Memorandum

Re: Update on design review for development of Block 85, Lots 10-18, New Meadows, ID

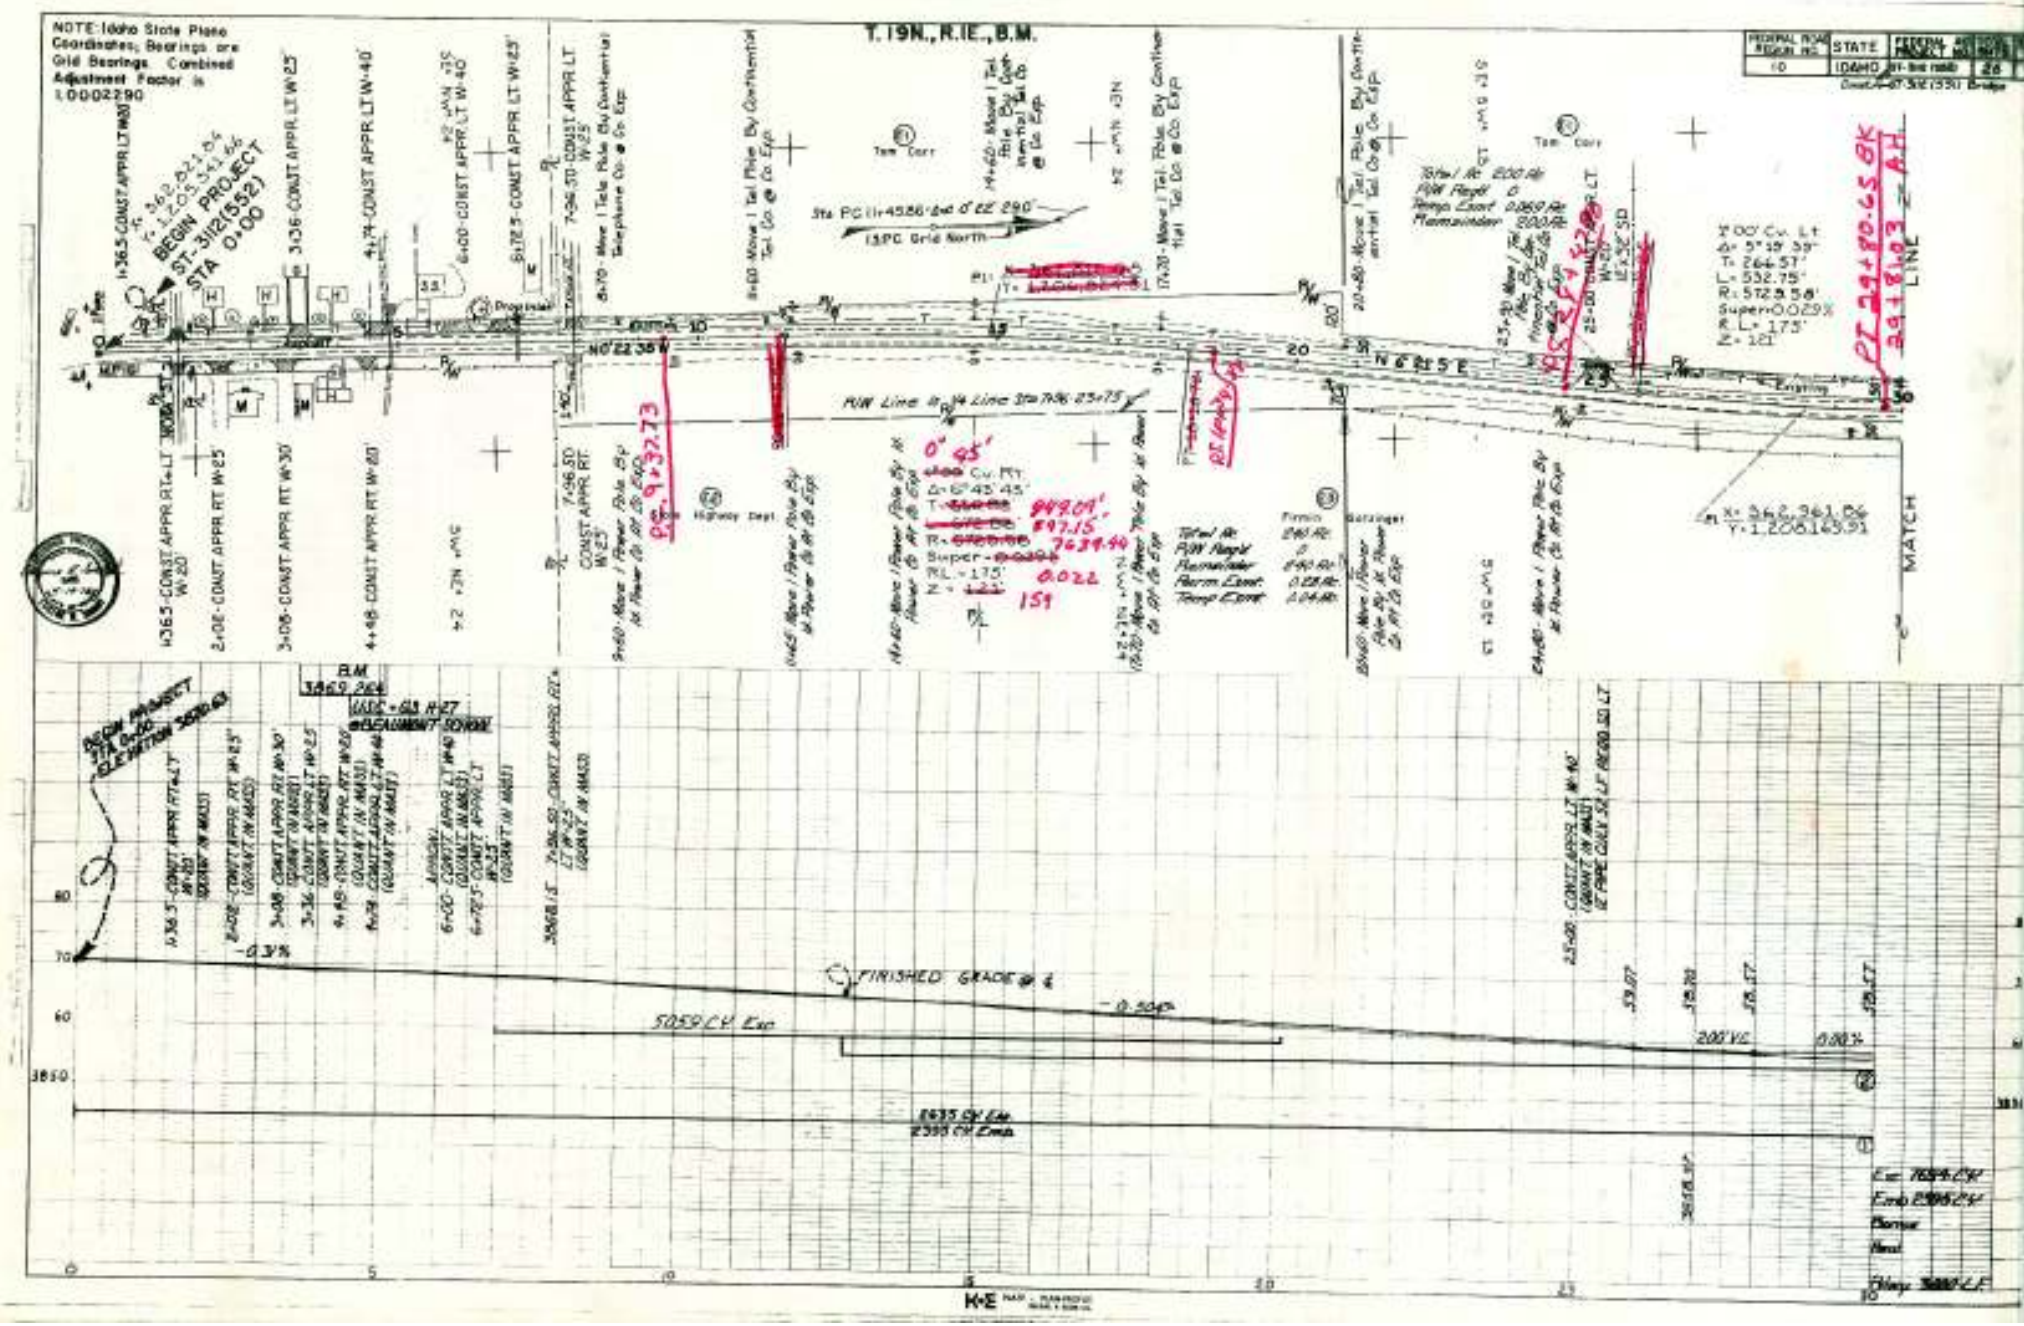
I have incorporated the elevation data provided by the district engineer for that section of highway 95 adjacent to the lot on which Mr. Brown has proposed his project. If he does erect a 26' building on the lot as illustrated in his drawing, my calculations indicate the structure will be (just barely) underneath the FAR part 77 approach surface for runway 32. Should he attempt to build structures higher or any closer to the runway end than his drawings indicate, there will most certainly be penetration of the protected airspace for that runway end.
